Sabre Sailing Association of Australia

Rule Changes passed by Special General Meetings held 30 November 2013 and 15th Feb 2014 which took effect on 1st and 15th February 2014.

SABRE DATUM POINT AND SECTION LOCATIONS

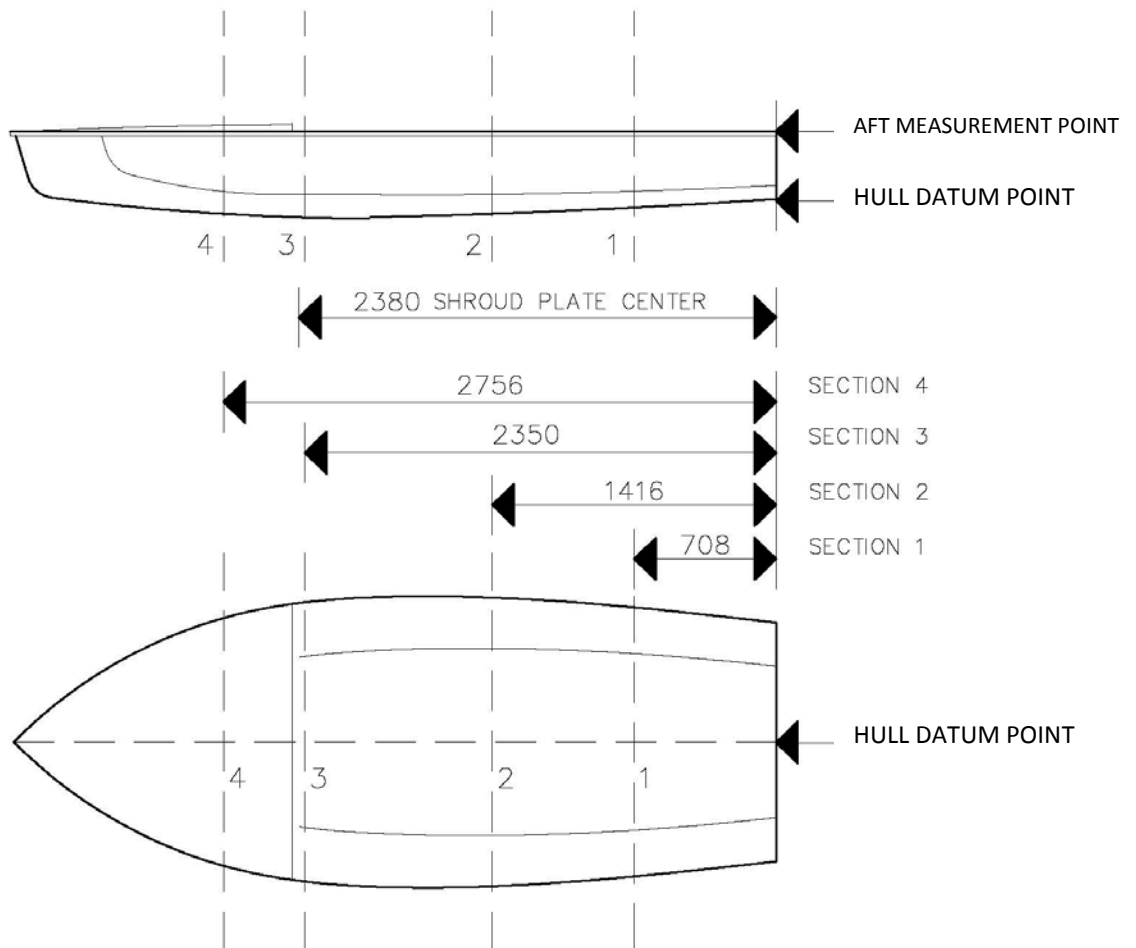
2. **Basic Hull Measurement**

Hull Datum Point (HDP): the lowest point of the transom on the centreline where the bottom panels meet transom.

Aft Measurement Point (AMP): is on the plane of the transom at the top of the transom centreline. The angle of the transom to the hull is controlled by the shape of the template for the side panel where the stern end of the side panel forms a right angle.

Forward Measurement Point (FMP): is the projection of the stern at the sheer on the centreline of the hull.

Measurement Sections - The Measurement Sections shall be defined by the following points measured along the hull centreline from either the HDP or AMP as appropriate:.

Section 1 – 708mm from the measurement point.

Section 2 – 1416mm from the measurement point.

Section 3 – 2350mm from the measurement point.

Section 4 – 2756mm from the measurement point.

8. Rudder cheek thickness and construction

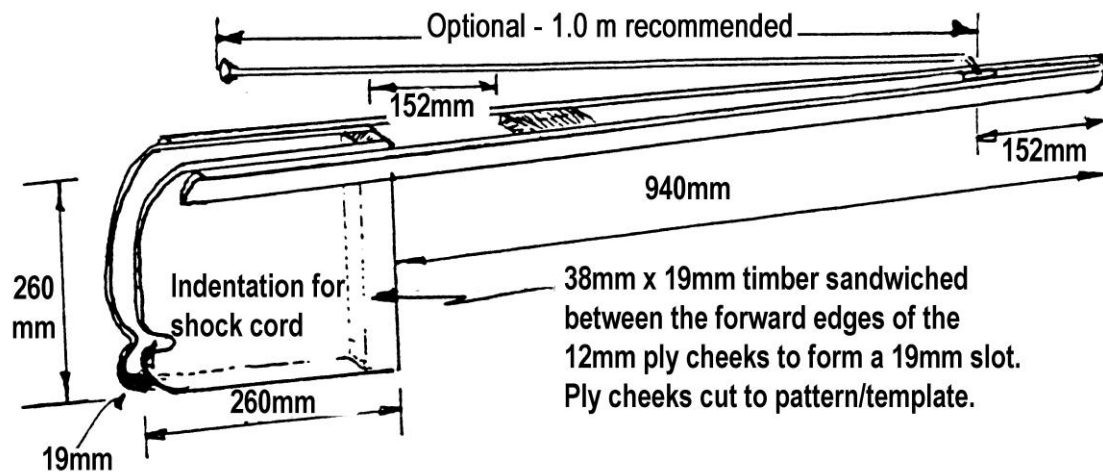
Diagrams 11 and 12 of the Construction notes refer to 12mm ply rudder cheeks and a 19mm slot. Modern rudder gudgeons have a narrower width which means that the cheeks need to be chiselled out to fit them. 9mm ply cheeks accommodate current commercial gudgeons and do not adversely affect the strength of the rudder stock. Current rules specify that rudder cheeks be made from plywood. There is no reason why the rudder box should not be a moulded FRP construction which is likely to be cost effective and possibly lead to more readily available replacements.

Diagrams 11 and 12 shown here are to be changed to reflect this;

Measurement No. 70 - Rudder box may be constructed from timber or moulded FRP.

Measurement No. 71 - Rudder box cheeks to be a minimum thickness of 9mm.

Rule 7.1 (c) as shown below is DELETED;

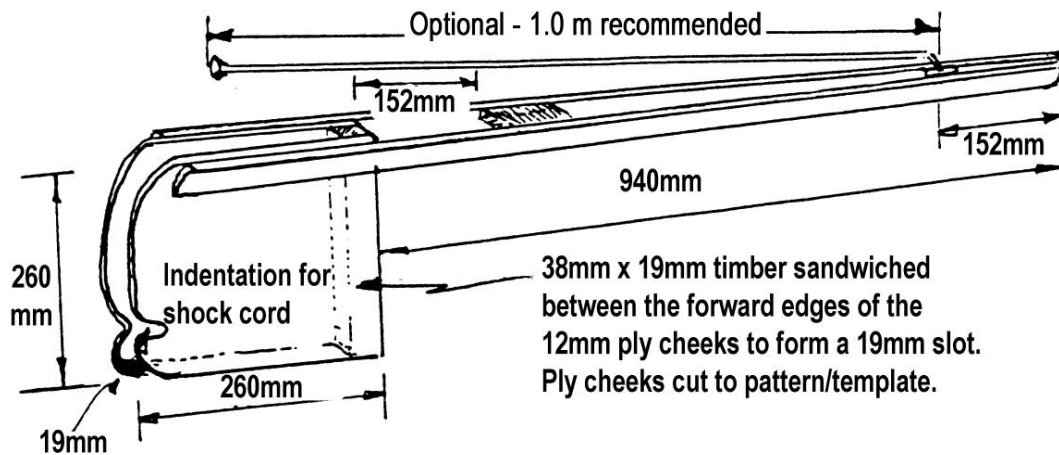
The boom is not sealed so there is no need for this rule to stop water entry. Allowing an internal control removes the possibility of the outhaul control line fouling on clothing or other items of the boat.

~~Rule 7.1 (c) - Control lines or halyards are not allowed within the boom section.~~

Diag.#11 - Rudder Stock with Timber Tiller

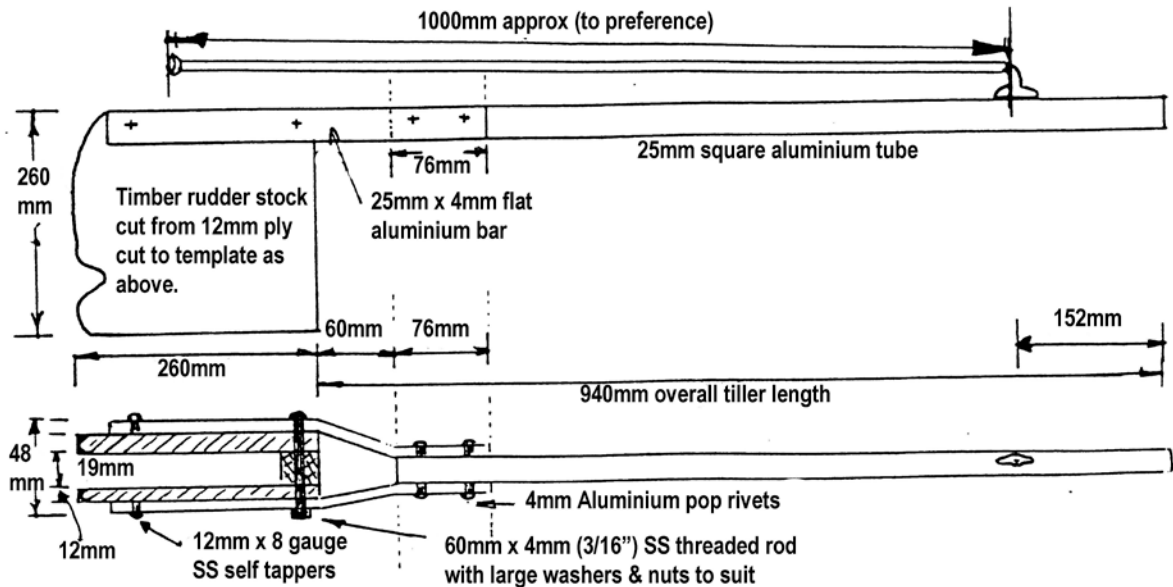
The table of measurements (57 to 72) do not contain minimum or maximum lengths for the tiller (timber or aluminium) but Diagrams 11 and 12 on page 26 of the Construction and Fitting Out Notes specify an exact tiller length of 940mm. The length of the tiller, like the tiller extension, **is now a recommendation only**.

Diag.#11 and Diag.#12 shown below are amended;

The recommended tiller length specification is 940mm.

Diag. #22 – Halyard Cleat Position as shown below;

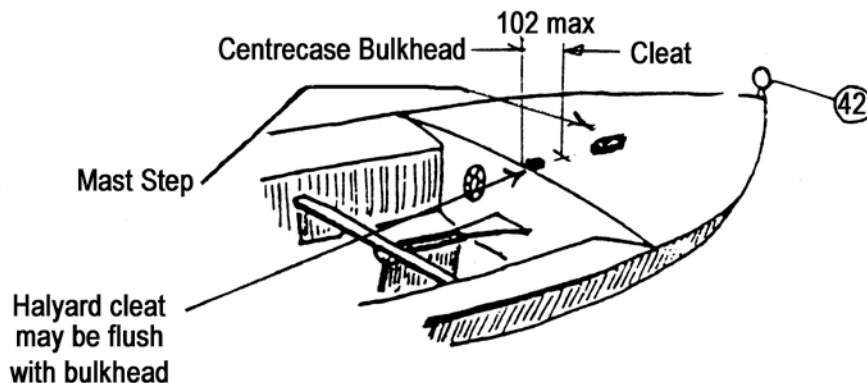
There is no clear reason for these measurements and there should be an option to cleat a rope halyard to a cleat attached to the top of the centrecase bulkhead.

Halyard Cleat (~~Meas #86, Diag. #22, Item 68 or 68A~~)

This must be a quick release cam or clam cleat, through which the rope halyard is fixed. Alternatively, a halyard lock may be used with a stainless steel halyard wire. The cam or clam cleat or halyard lock must be mounted as shown above.

Changing "102 max" to "102mm – recommended" in the diagram.

Last sentence now reads "The cam or clam cleat or halyard lock may be mounted as shown above or on and near the top of centrecase bulkhead."

The words "(Meas #86, Diag. #22, Item 68 or 68A)" are deleted.

The following sentence in Step 49 is DELETED

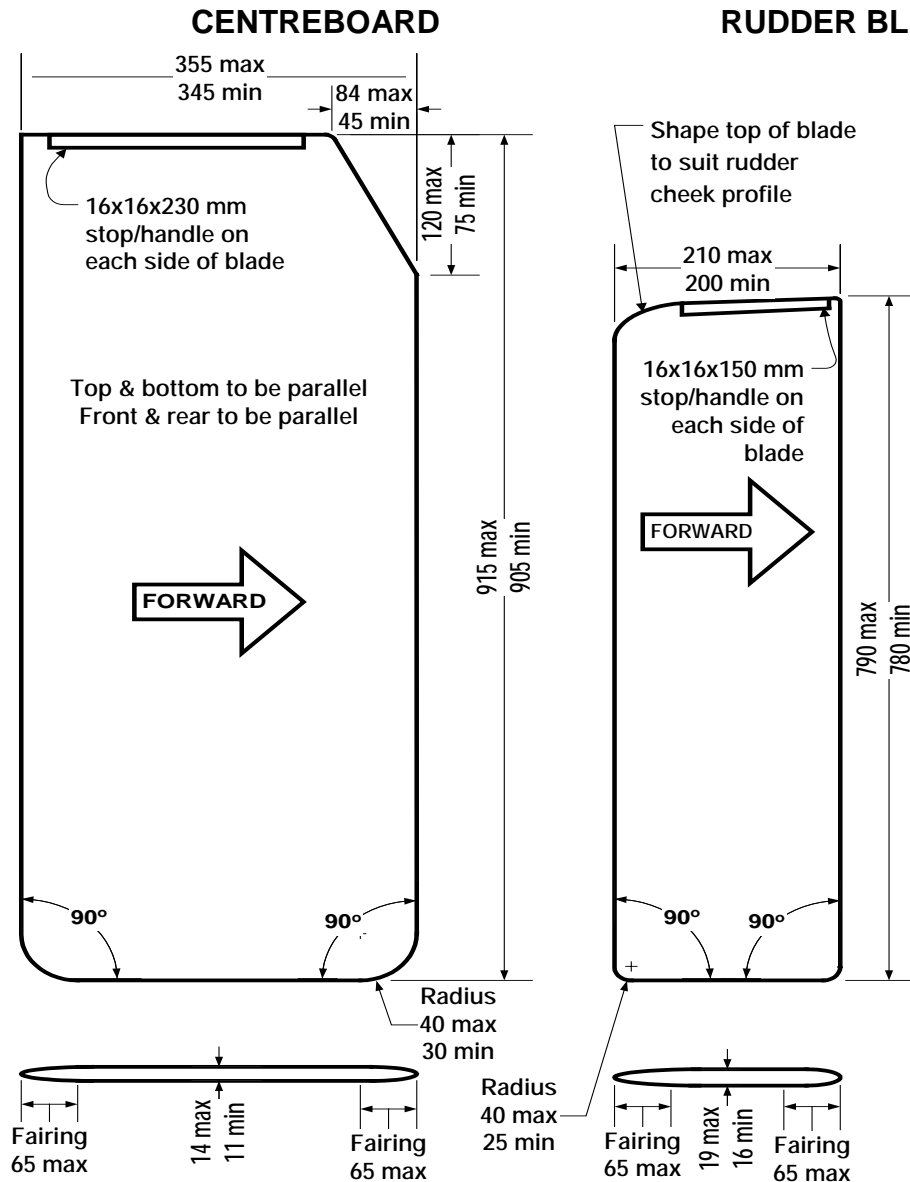
- 3.1 a. The centreboard shall be constructed to the profile illustrated in **Diagram #13** in the Construction & Fitting Out Notes, of plywood, solid or laminated timber, and may be finished with a skin of fibreglass, such skin being included in the thickness dimension, or may be constructed of FRP material.

~~These may only be constructed by builders authorised by the SSAA.~~

Diag. #20 – Mainsheet System

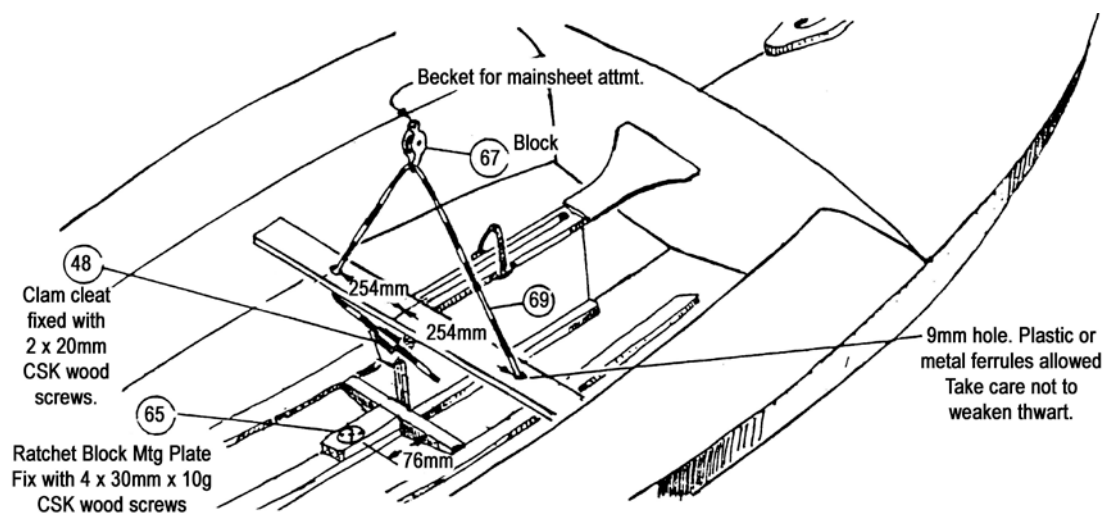
Ratchet blocks are optional in the mainsheet system. It was traditional in the 1970's to attach a ratchet block as per Diag #20 but there is no reason why a ratchet block cannot be attached to the boom, or for that matter have one mounted off the keel and another on the boom. Diag #20 does not reflect the modern practice of attaching the last block off the floor by rope stop. Many sailors no longer adjust the rope hawse while sailing and just tie it off, so the requirement for a clam cleat is now formally an option.

Fit ratchet block and mounting plate to the keel cover block as shown in diagram (**Item 66**).

References to fitting 'Item numbers' removed

The 3rd sentence now reads "Fix a knot in one end of the hawse; pass through the first hole in the thwart; through the ferruled end of the mainsheet block (**Item 67**); through the second hole in the thwart, thence optionally to clam cleat fixed to the thwart or tied off to a saddle on the keel.

The sentence "Fit ratchet block and mounting plate to the keel cover block as shown in diagram (**Item 66**)" is deleted.

Diag. #20 deleted.

Diag. #25A – Mast Layout now prefaced by the following:

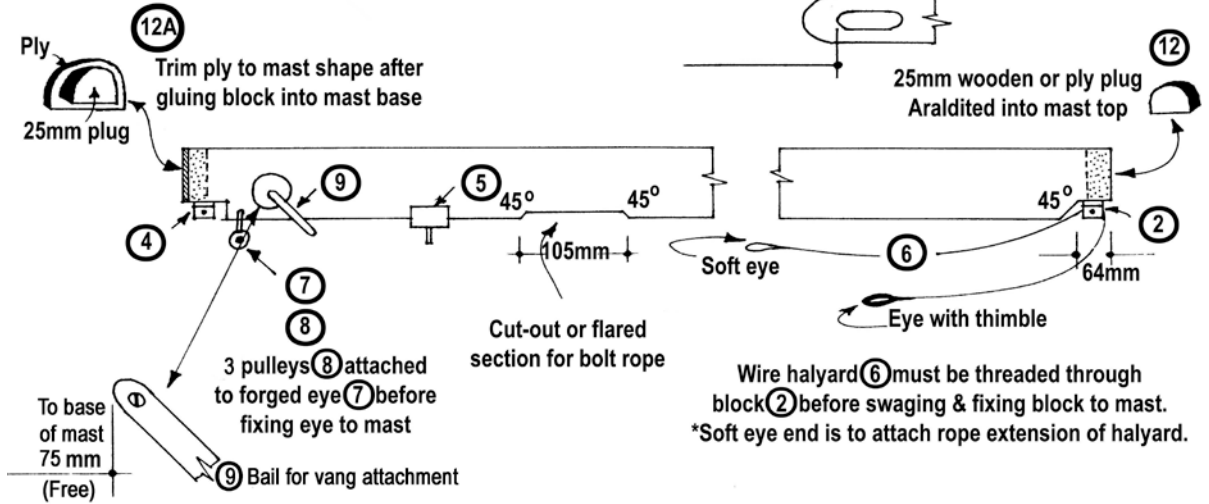
The method specified for attaching shrouds to mast tangs in Diag #25A is by permanent swage but common practice is to use cleavis pins or small shackles. The diagram refers to a 'wire halyard' but rope is the most common material these days. The vang attachment point drawing is obsolete.

The following diagram refers to "shrouds swaged to tangs" and "wire halyard". Shrouds may optionally be attached to tangs by using swages, cleavis pins or shackles. The halyard material is optional. The block hanger for attaching the vang shown in Diag #25A is optional.

Diag. #25B – Mast Base Measurements

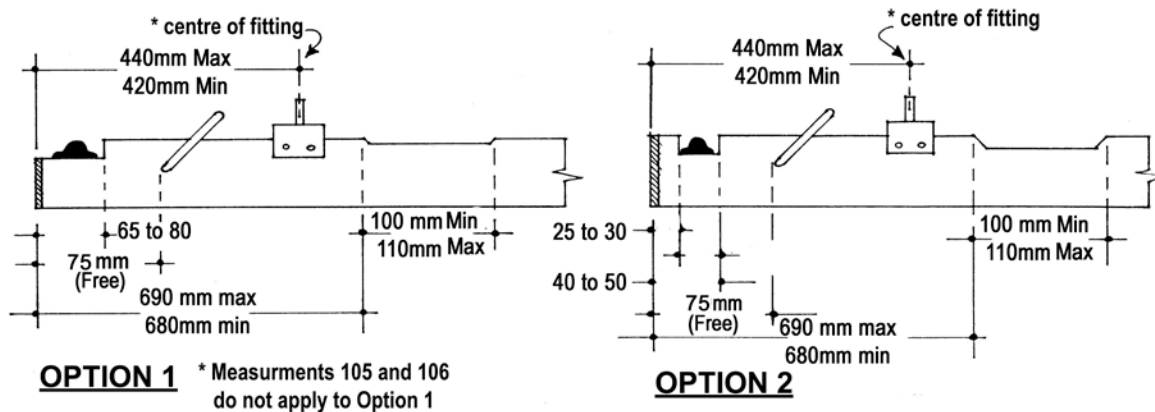
The specification for the position on the mast where the vang is attached was deleted Nov 2006) but Diag #25B still shows measurement points. The diagram is now prefaced to indicate that the vang attachment measurements are a guide only.

The method of attaching the vang to the mast is optional and the positions shown in Diag #25B (showing use of a block hanger) are a guide only.
